CITY PROJECT NO.
--
RAMSEY, MINNESOTA

PRELIMINARY STORM PLAN
RUM RIVER RETREAT
SUNDANCE WOODS, LLC

1.10 - SS - RRR.pdf V2 - Changemark Notes (1 Note)

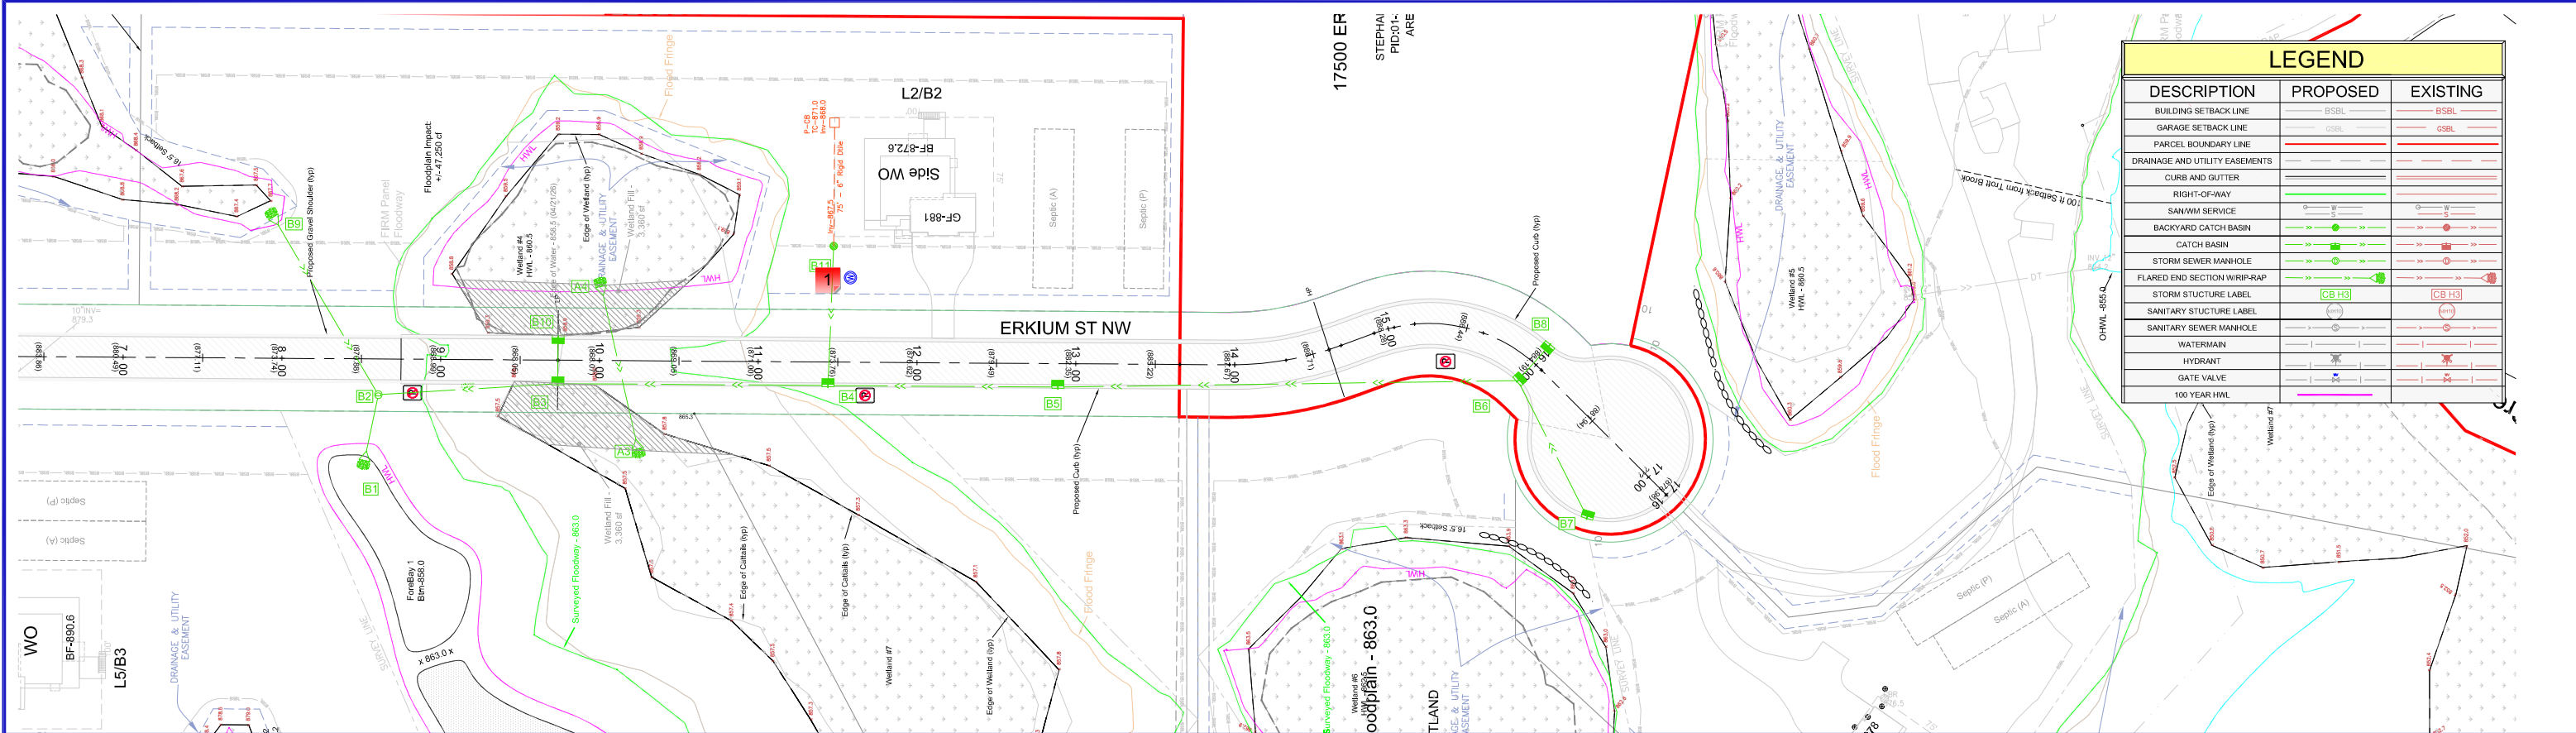
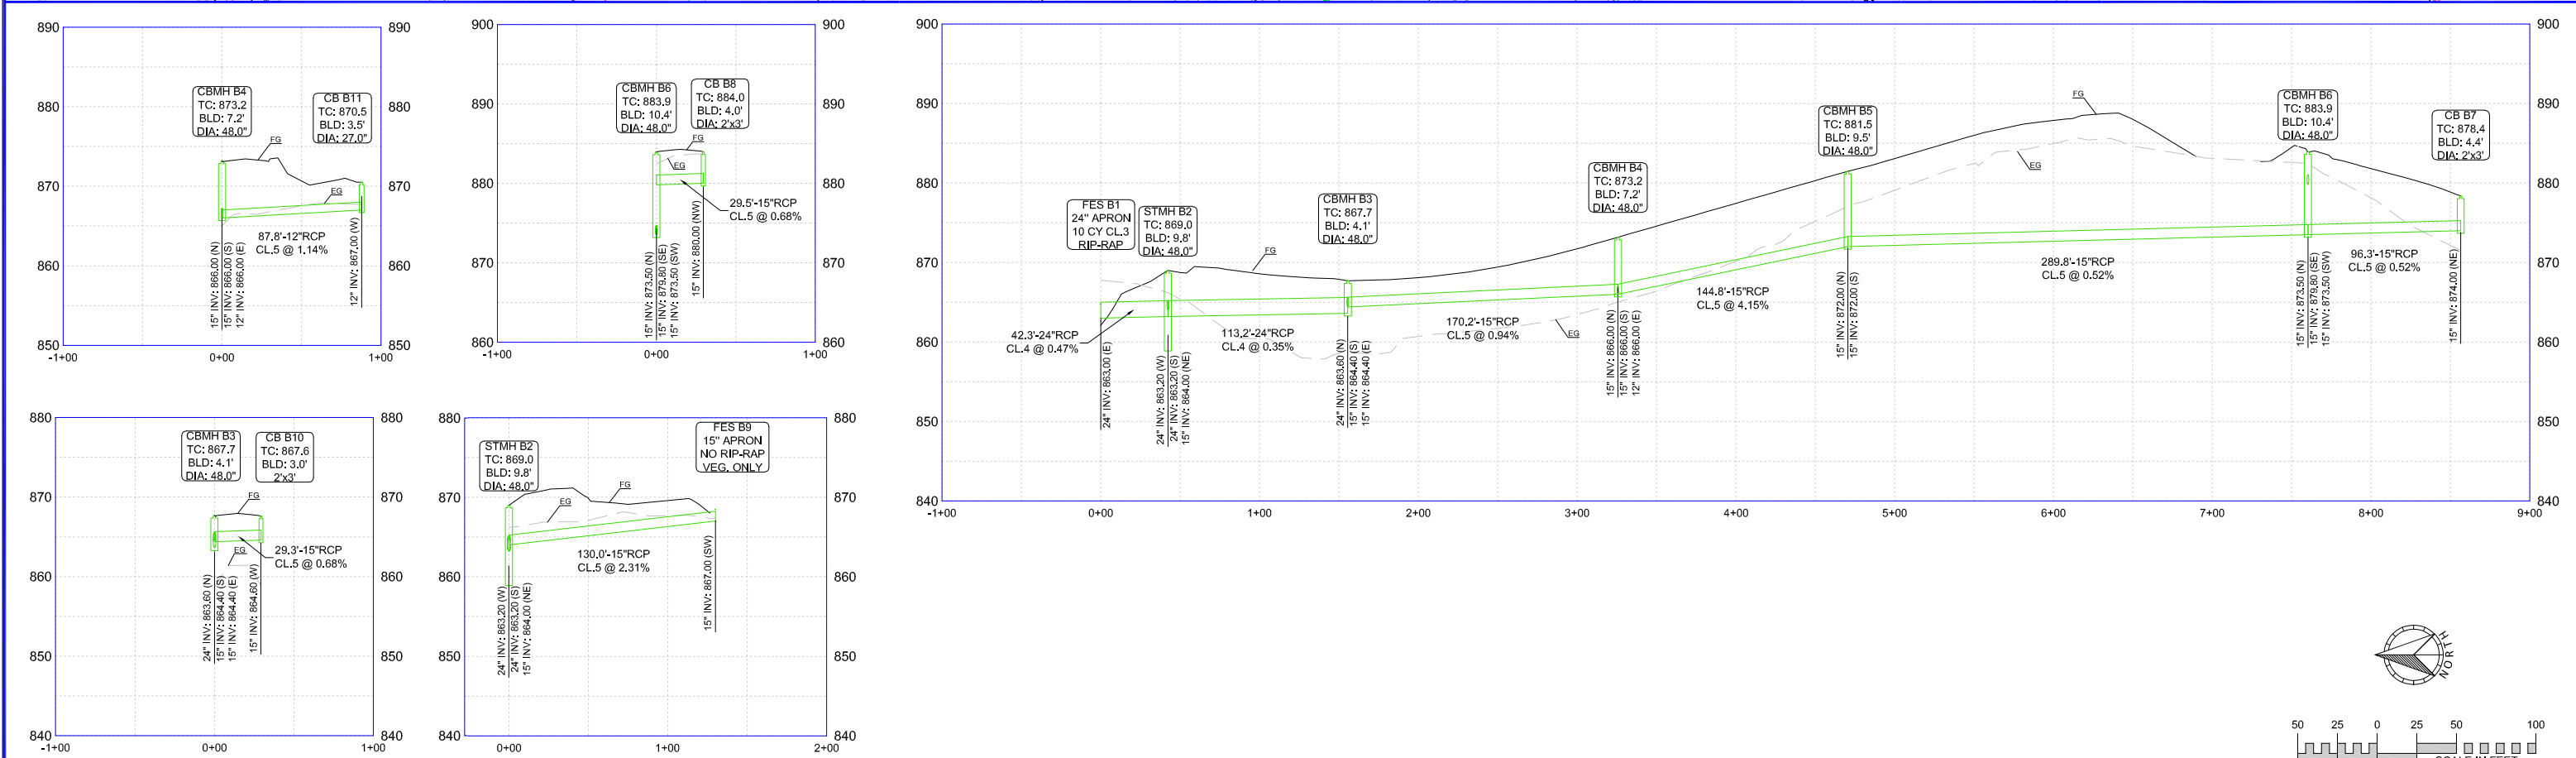
1 - Storm Line and Well

Confirm minimum 10 feet of separation between storm line and well.
